CITY OF SANTA ANA

Application Description: Expanding existing unit 500 into 550 & 555: Adding demising walls, locker rooms, add non-bearing partitions, realign ceiling and mechanical systems

TENANT IMPROVEMENT PLAN CHECK COMMENTS

PLAN CHECK NO:	10173124	
PROJECT ADDRESS:	200 W Santa Ana Blvd Unit# 500	
PLAN CHECK ENGINEER:	Mazarji, Zac	TEL: 714 647-5831
		FAX: 714 647-5897
TYPE OF CONSTRUCTION:	I A, SPK	
OCCUPANCY CLASSIFICATION(S):	B	
PLAN CHECK DATES:		REMARKS/RECHECK ITEMS:
APPLICATION	9/6/2011	
INITIAL REVIEW	9/7/2011	
EXPIRATION	3/4/2012	
RECHECKS:	1. 2. 3.	PROJECT APPLICANT CONTACT PERSON: Fraser McClellan
VALUATION:	\$300,000.00	TEL: (714)897-3382
FLOOD ZONE:	X-0602320276J	FAX: (714)897-5952
		EMAIL: Fraser@FMAcorp.com

PARKING STRUCTURE ENTRY NTS 07

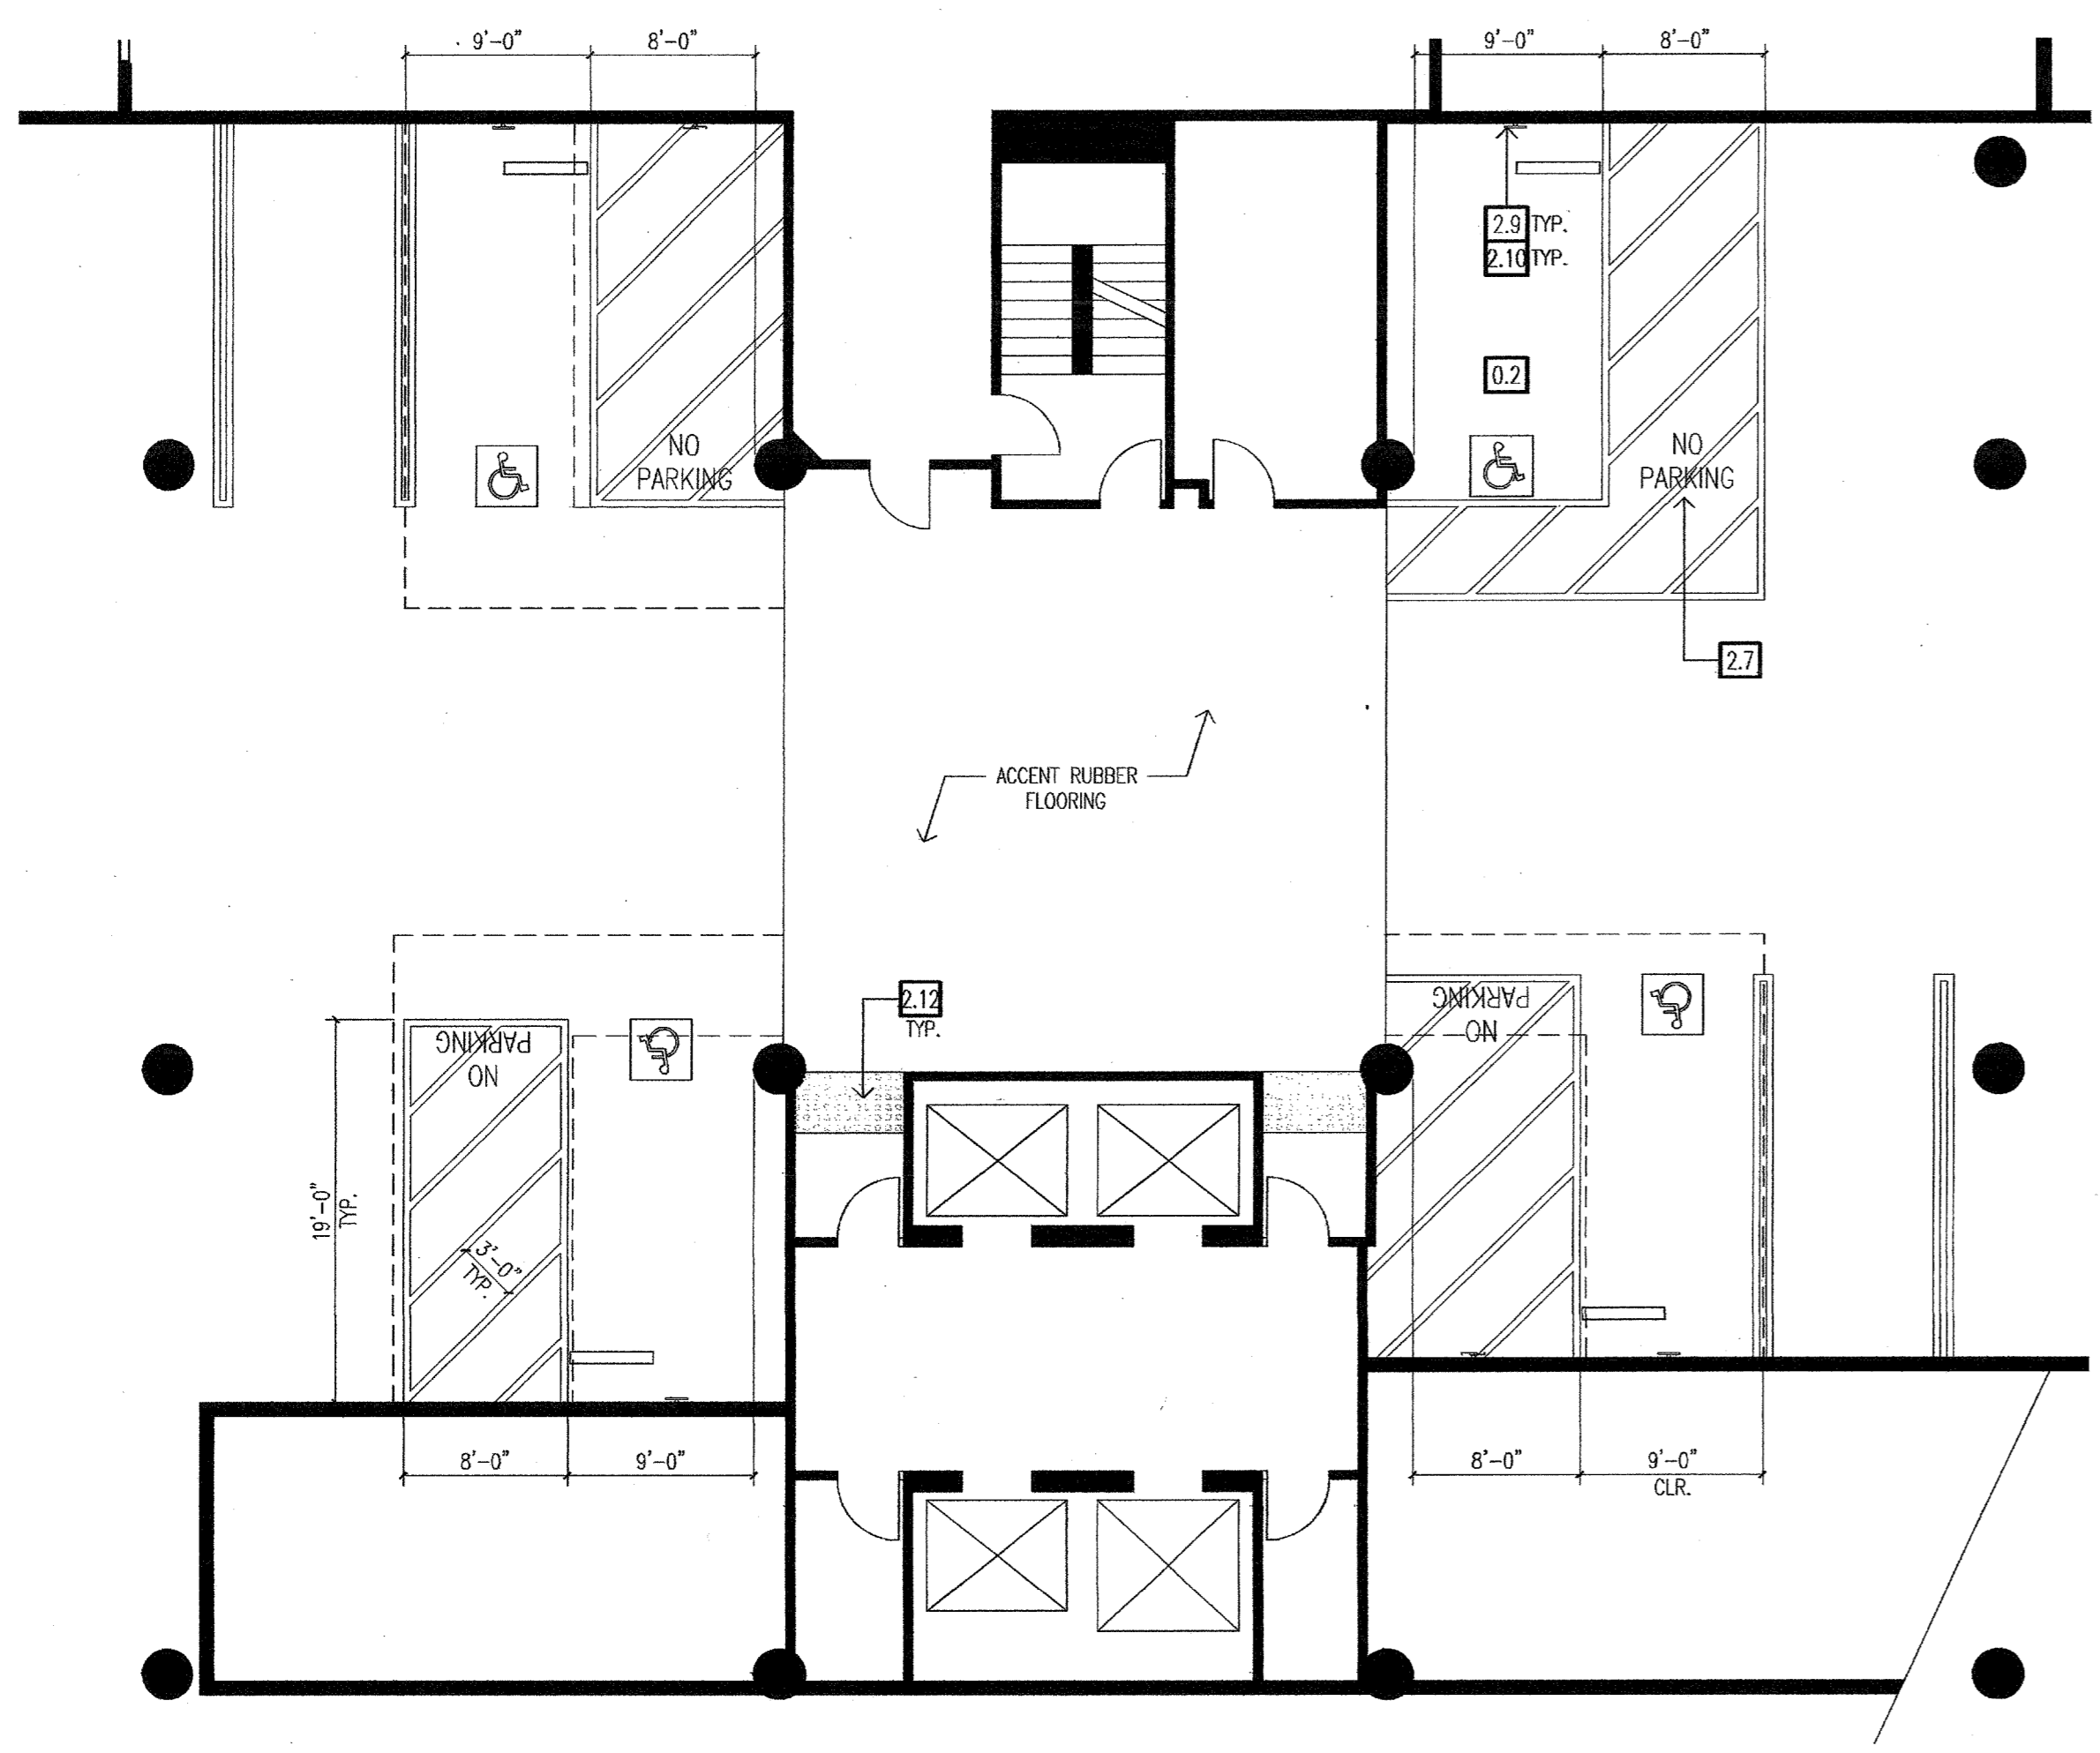
36. **Provide parking space identification in accordance with CBC Section 1129B.4 including:**

- CORRECTIVE WORK**
- 2.1 NEW STALL STRIPPING AS SHOWN ON PLAN
 - 2.2 PROVIDE NEW POST AND WALL MOUNTED SIGNS AT ALL STALLS. SEE SIGNAGE DETAILS ON THIS SHEET
